Re: Hexavalent Chromium Mitigation Efforts

**Re: Response to Comments Regarding Downgradient Property Status Opinion
44 Bowditch Drive
Shrewsbury, Massachusetts
RTN 2-20057**

Re: Response to DPS Filed by Metso, Inc.
Shrewsbury, Massachusetts
Release Tracking Number (RTN) 2-20057

Attachment: Figure 1

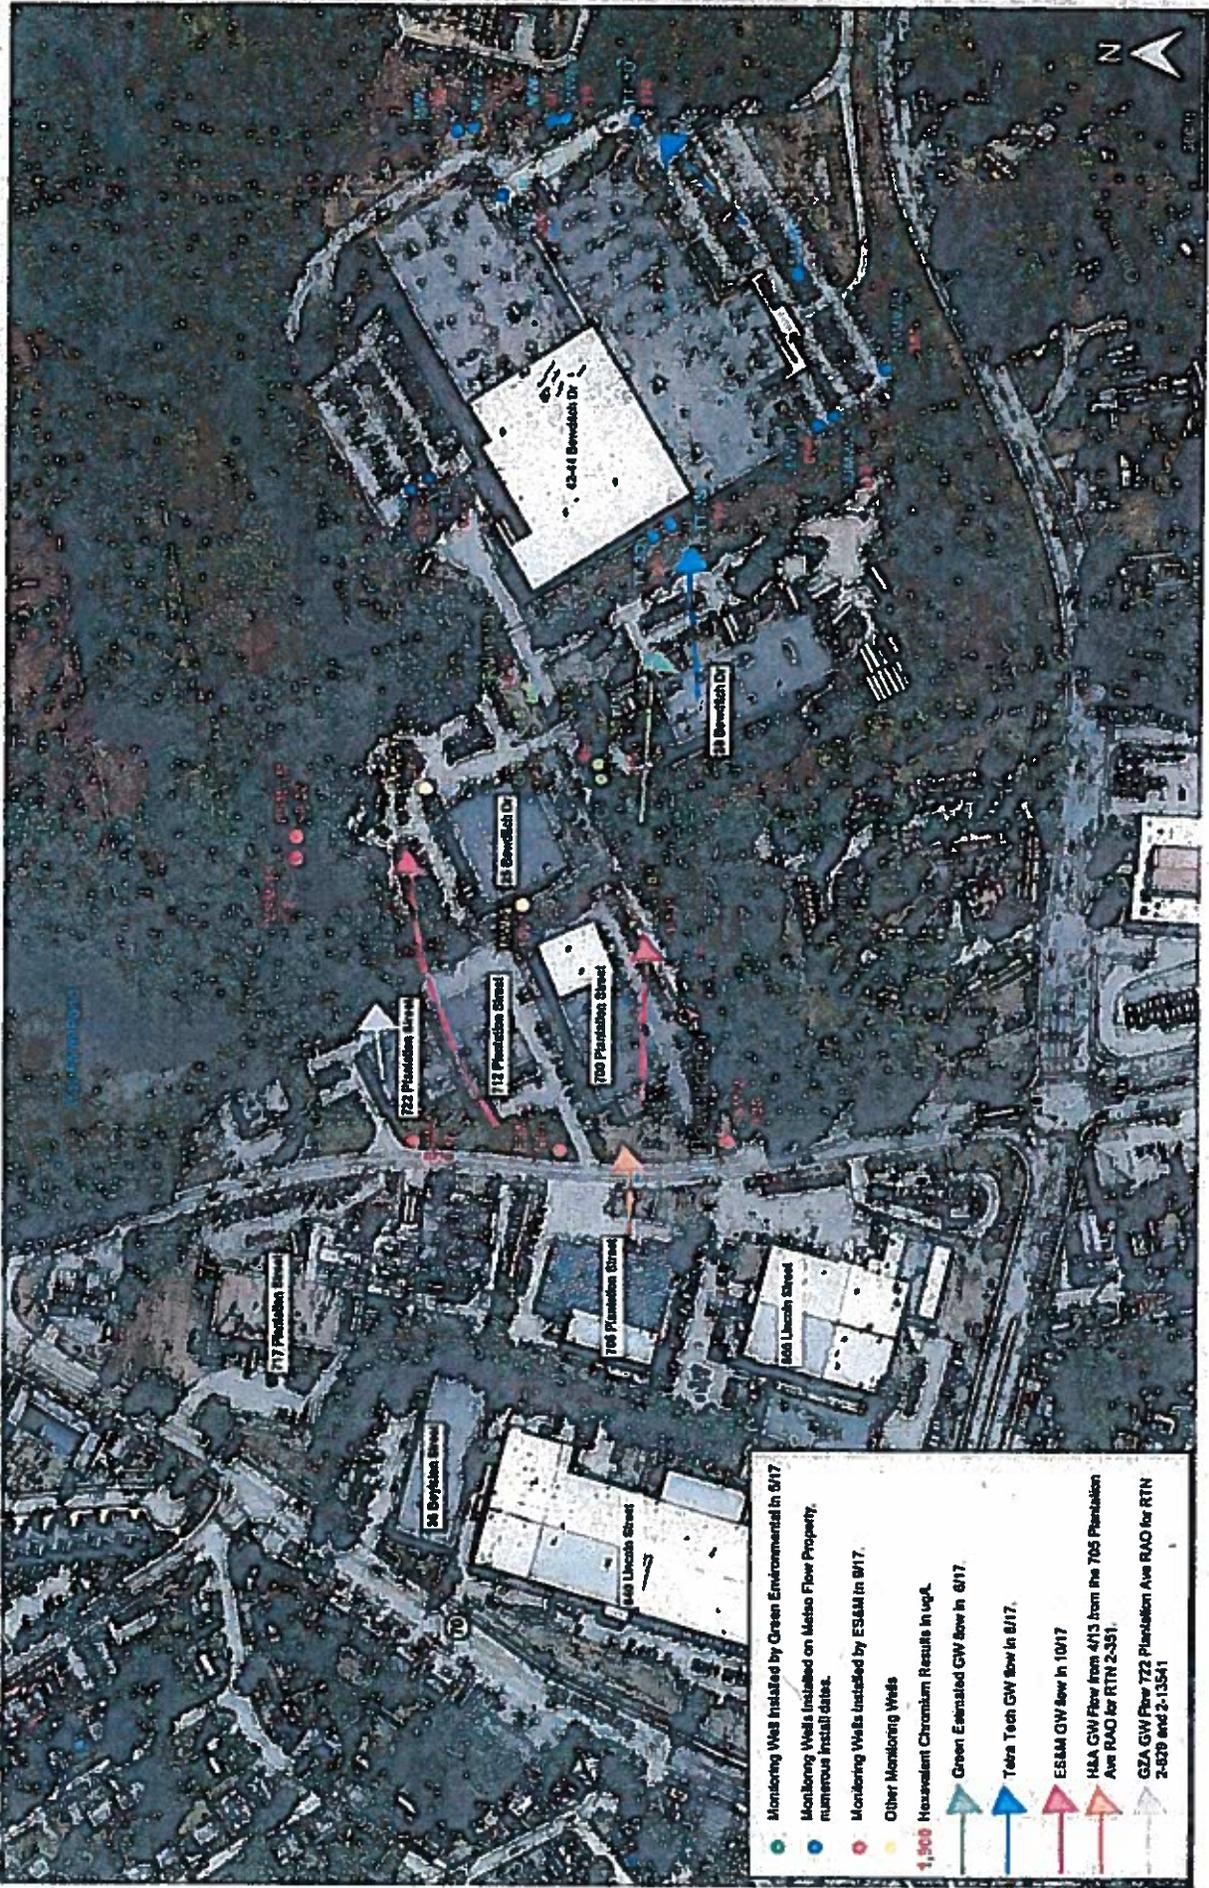
The use of the groundwater flow directions depicted on the figure attached to the June 1, 2018 letter as the basis for the conclusion that Garrepy is not the source of the elevated concentrations of hexavalent chromium detected in the area of Bowditch Drive and on the Site is flawed for the following reasons:

- The groundwater flow directions identified on the Garrepy and 705 Plantation Street properties are based on historic measurements of groundwater elevations on those relatively small parcels at different times, so the directions of groundwater flow are indicative of localized conditions and do not consider the overall, regional direction of groundwater flow or changes in the flow direction as groundwater migrates from those parcels to downgradient properties.
- The groundwater elevations measured by Tetra Tech, Green Environmental and ES&M reflect water levels measured at single points in time, and do not characterize seasonal variability in groundwater elevations or flow directions or the influence of pumping the Town of Shrewsbury wells on groundwater elevations and flow directions.

In addition, the groundwater flow directions identified by GZA are based on water levels measured in monitoring wells screened in overburden rather than in bedrock.
